CALIFORNIA COASTAL COMMISSION

COASTAL DEVELOPMENT PERMIT APPLICATION

Application number3-01-111, Pelican Point Riverwall

Project descriptionInstall a driven sheet-pile metal wall along roughly 715 linear feet of the Pajaro River and Watsonville Slough sides of the Pelican Point condominium portion of the Pajaro Dunes residential development.

RIVER/SLOUGH
SIDE OF
SHEETPILE WALL

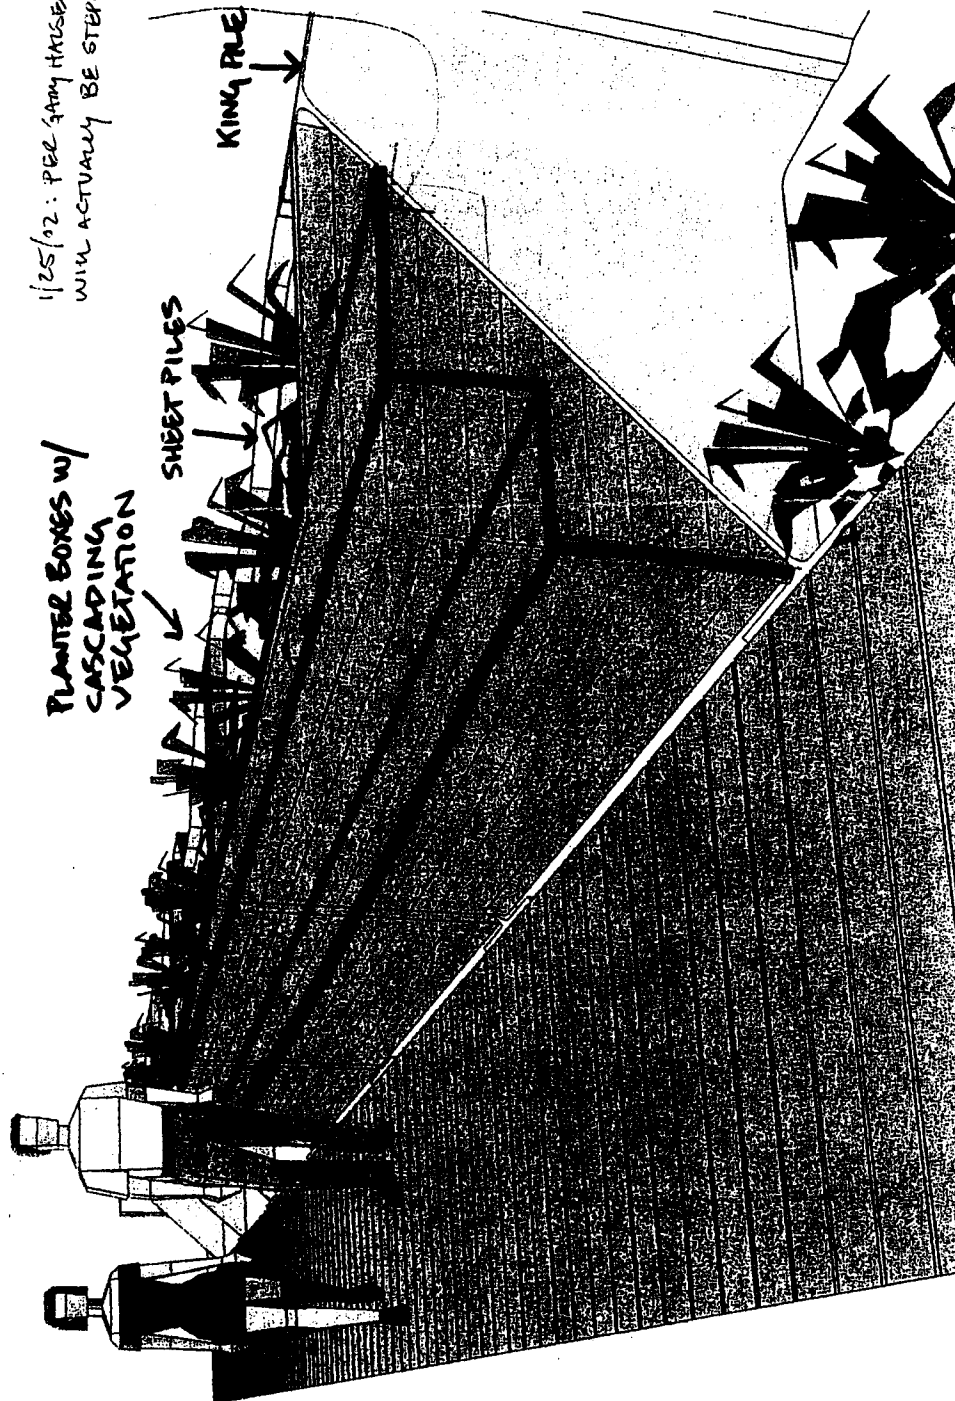
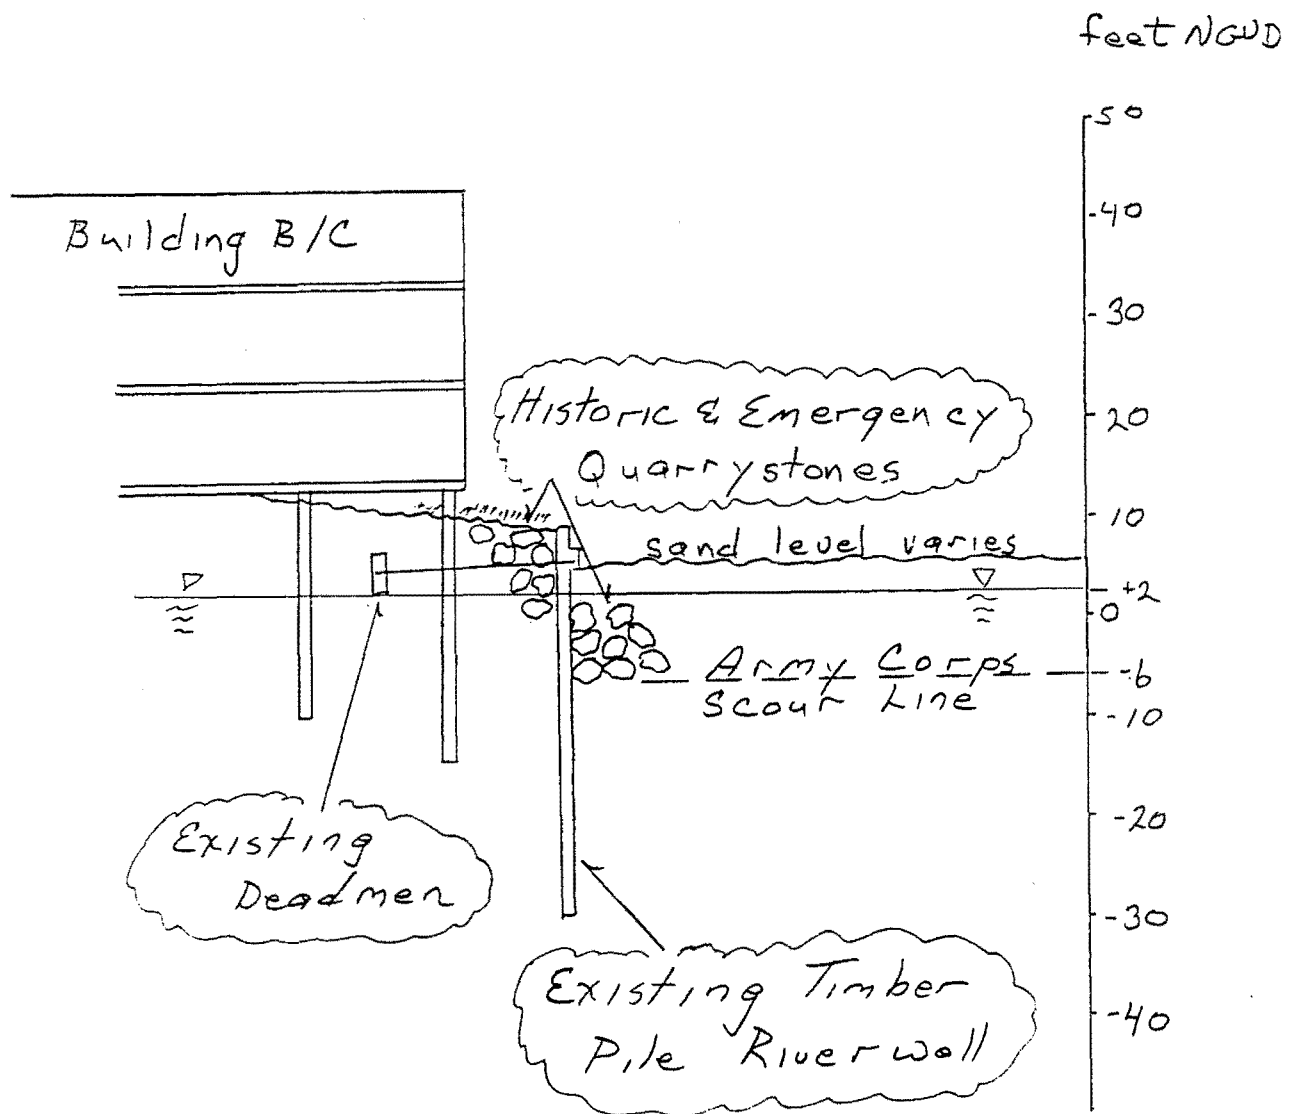
1/25/02: PER GARY HATSEY,
WILL ACTUALLY BE STEPPED

Undulating Wall Concept
 21 March 2002

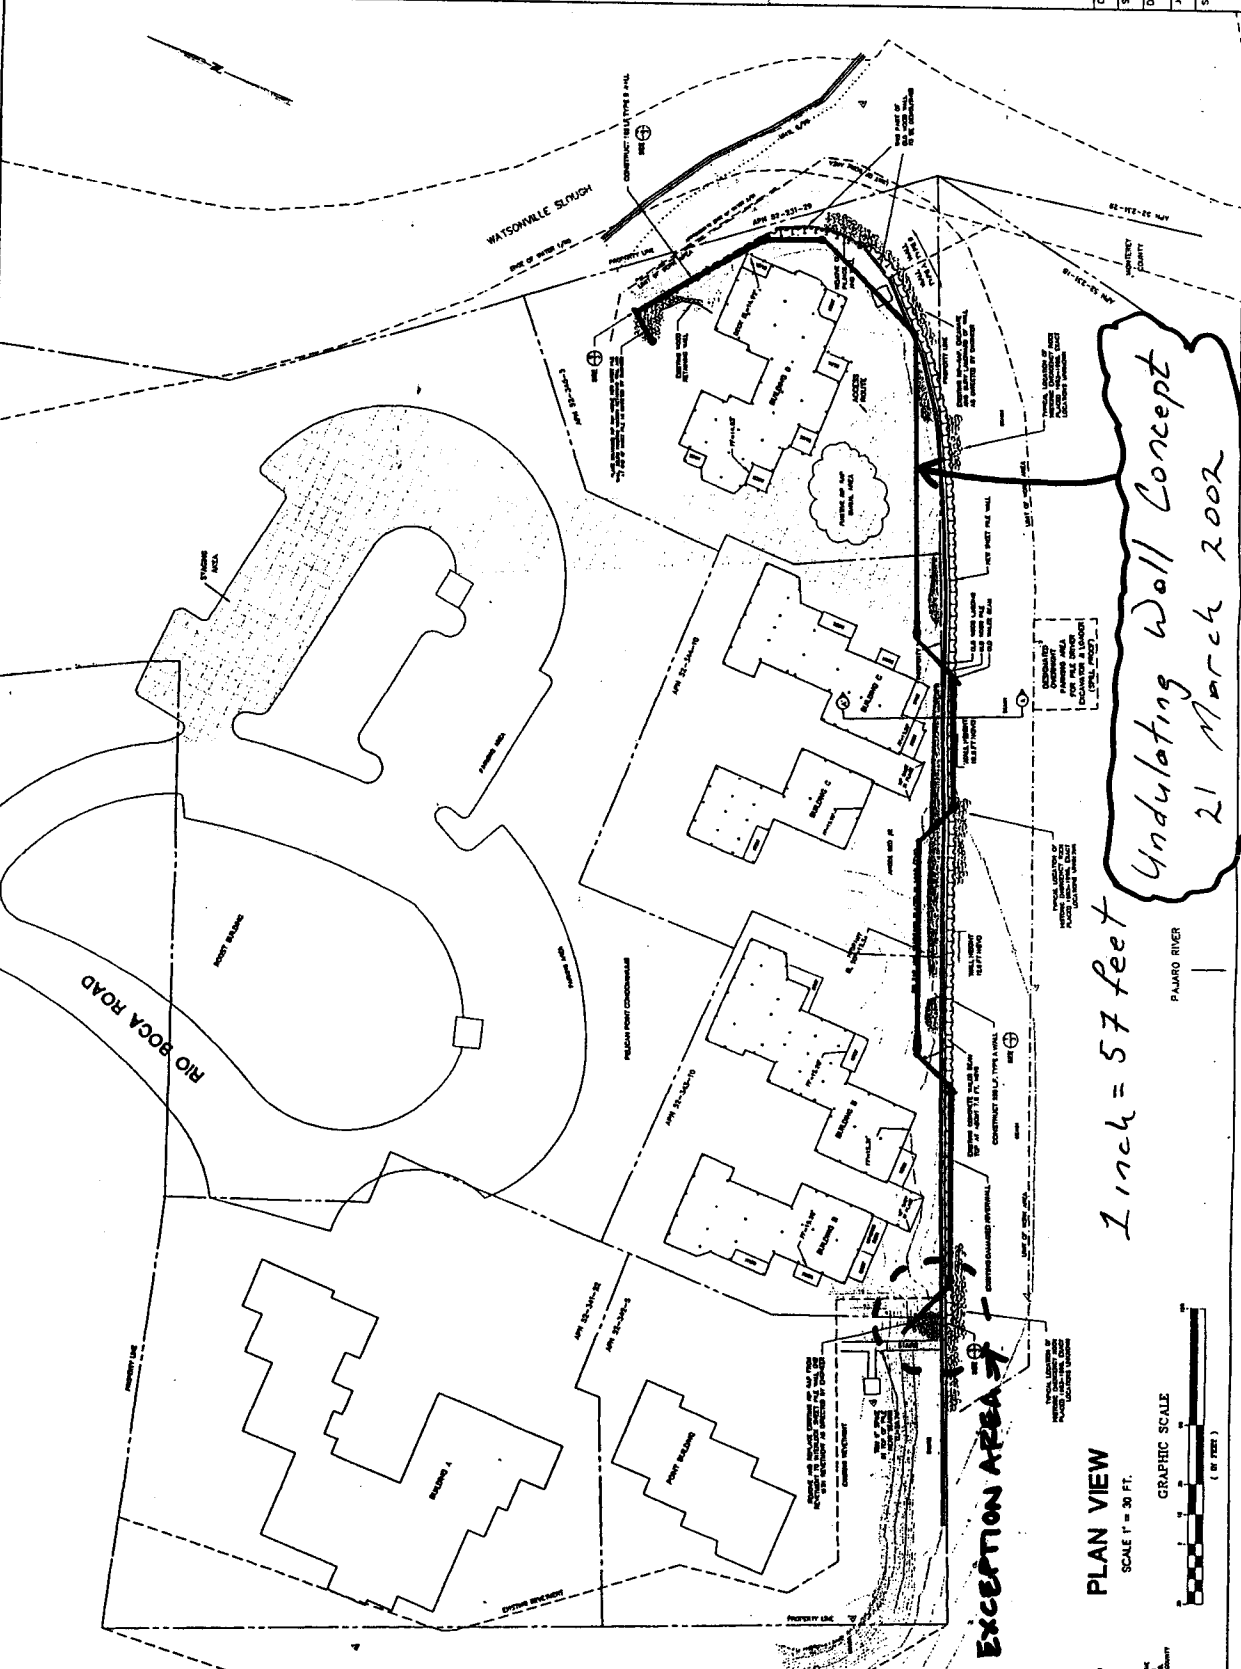
1. **Revised Sheetpile Wall Plans.** PRIOR TO ISSUANCE OF THE COASTAL DEVELOPMENT PERMIT, the Permittee shall submit Revised Sheetpile Wall Plans to the Executive Director for review and approval. The Revised Sheetpile Wall Plans shall be substantially in conformance with the plans submitted to the Coastal Commission (*Pelican Riverwall Repair Plan* by Haro, Kasunich and Associates Inc. dated received in the Coastal Commission's Central Coast District Office January 25, 2002) but shall show the following changes to the project:
 - (a) **Undulating Wall.** The sheetpile wall shall be located in the alignment identified in the March 22, 2002 Haro, Kasunich and Associates Inc. letter report and identified as "Undulating Wall Concept 21 March 2002" (see exhibit D). For the two locations where the sheetpile wall would

be placed on the Pajaro River side of the existing wood pier and lagging wall (at Pelican Point condominium buildings B and C), the Revised Sheetpile Wall Plans shall indicate that the sheetpile wall shall be installed as close as possible to the existing wood wall, shall extend the minimum length necessary on the river side of the wall, and in no case shall its face extend more than five feet south of the location of the face of the existing concrete whaler beam. The wall may be constructed on the Pajaro River side of the existing wood pier and lagging wall in the area labeled as "Exception Area" on page 1 of exhibit E (i.e., that area nearest the existing revetment and stairway).

The Commission finds that the most Coastal Act consistent project is the undulating wall alternative with one caveat. Little resource value is gained by crossing the wall inland between Building B and the stairway (at the westernmost end of the project area – see exception area shown on exhibit E). This area is occupied by revetment, and it would make better engineering and resource sense to contain this revetment within the sheetpile wall, and to connect the sheetpile wall and interior pathway to the existing stairway. This revised alternative still raises the same impact and Coastal Act inconsistency issues identified above for the proposed project, but it reduces the area in which the wall is located on the river/slough side of the existing wall to roughly 200 linear feet along the sandy rivermouth area (where the condominium buildings prevent a more inland location), and none along the Watsonville Slough area. Thus, this approval is conditioned for revised final plans for the undulating wall alternative. Such plans must minimize any necessary construction on the river side of the existing wall to the absolute minimum necessary. See special condition 1.

RESTORATION
AREA ON
RIVER/SLOUGH
SIDE OF WALL
AND CONDOS

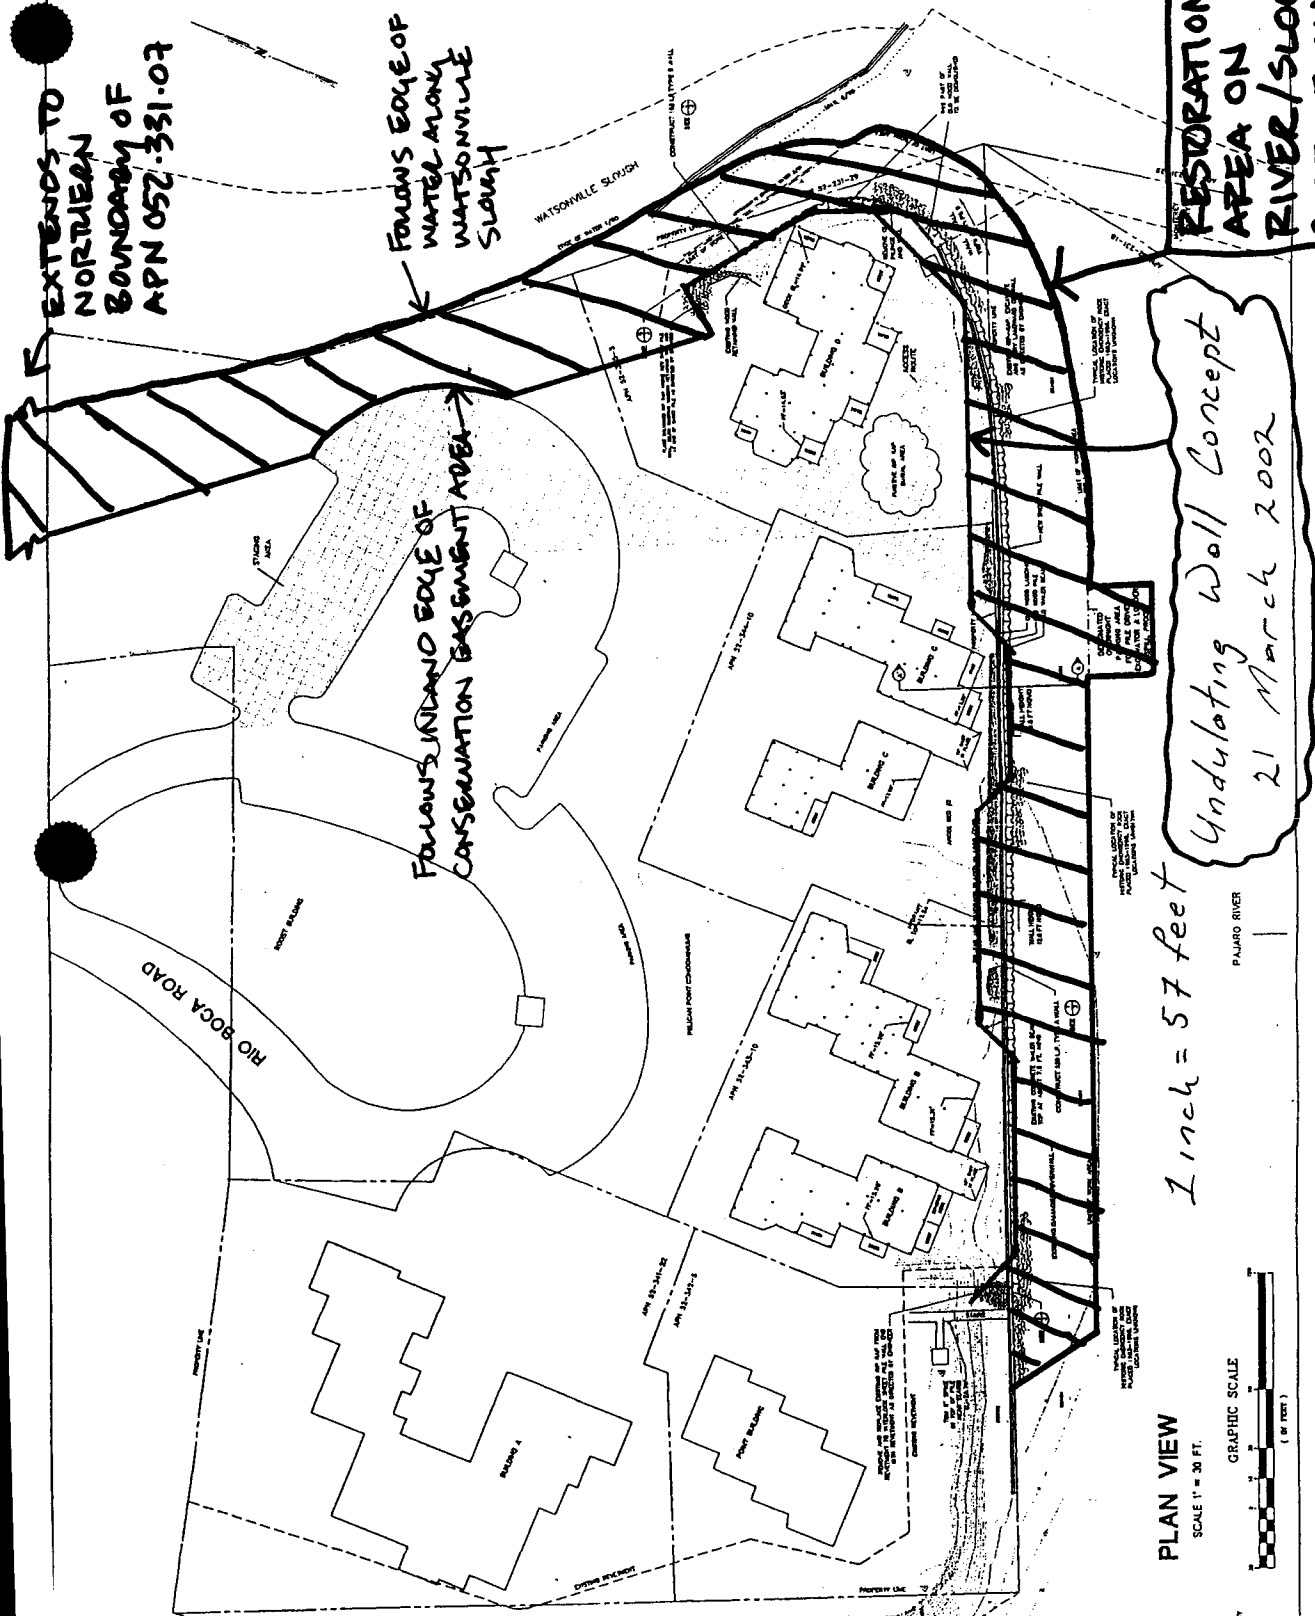
- (a) **Expanded Restoration Area Adjacent to Sheetpile Wall.** The Revised Restoration Plan shall provide for high quality dune and slough restoration of all areas located on the Pajaro River/Watsonville Slough side of the revised undulating sheetpile wall location (identified in the approved Revised Sheetpile Wall Plans per Special Condition 1 above); see page 2 of exhibit E for graphic depiction of this area.

- (b) **Expanded Restoration Area Adjacent to Watsonville Slough.** The Revised Restoration Plan shall provide for high quality wetland/upland restoration and habitat enhancement in the area north of the sheetpile wall as shown on page 2 of exhibit E. All invasive non-natives shall be removed from this area, and significant trees shall be retained.

All areas on the river/slough side of the sheetpile wall within the construction zone must be restored to provide high quality habitat (see restoration area detail in exhibit E). The Applicant will need to submit a revised restoration plan for this purpose consistent with the Commission's generally accepted parameters for such plans. See special condition 2.

The area north of the project site on the Applicant's property between the waters of Watsonville Slough and the paved roadway area (i.e., the general area for which the Applicant has proposed a conservation easement) must be restored to provide high quality slough habitat. The revised restoration plan must be extended to cover this area as well (see restoration area detail in exhibit E). See special condition 2.
